PUBLIC INTEREST TECHNICAL REVIEW FOR GROUNDWATER APPLICATIONS

TO: Water Rights Section Date: 8/15/2025
FROM: Groundwater Section Grayson Fish
Reviewer's Name
SUBJECT: Application G - 19500 Supersedes review of _____

Applicant's Name: Bandon Biota LLC County: COOS
Applicant(s) seek(s) 0.2673 cfs from 5 well(s) in the South Coast Basin,
_____ subbasin

Water-Level Measurements in Nearby Wells

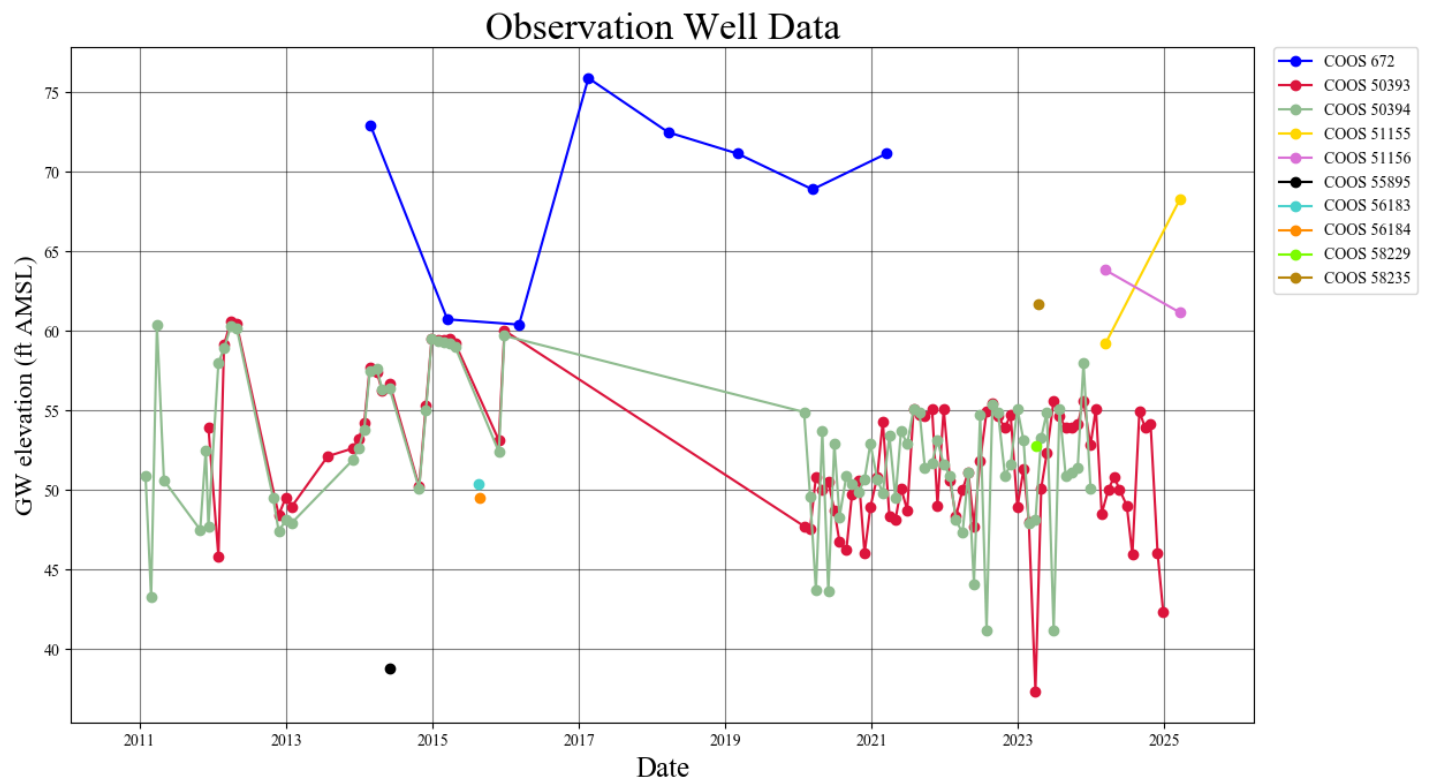
POAs 1 through 4 appear to source water primarily from an unconfined aquifer within the unconsolidated sediments (dune and marine terrace deposits). POA 5 is sealed through the unconsolidated sediments to a depth of 155 feet and obtains water from bedrock. POAs 1 through 4 have greater/higher reported well yields and static water levels than POA 5 as displayed in table A2 d. The static water elevation of POA 5 is similar to nearby POA 2, suggesting that the aquifer is interconnected between the bedrock and sediments. Elevations of static water levels reported at time of the POAs well construction are similar to elevations of static water level measurements in wells located in the marine terrace to the east suggesting a laterally continuous aquifer (see attached hydrograph).

Comments: There is insufficient data available for proposed POA wells 1 through 5 to perform the Rate and Magnitude tests. However, static water level measurements from COOS 672, COOS 50393 and COOS 50394 located in the marine terrace deposits east of the POA indicate that water levels are reasonable stable in the source aquifer to be accessed by the proposed POAs.

Comments: Water level measurements in wells located approximately 0.5 mile east of the site indicate that groundwater levels are reasonable stable in the aquifer to be accessed by the proposed POAs.
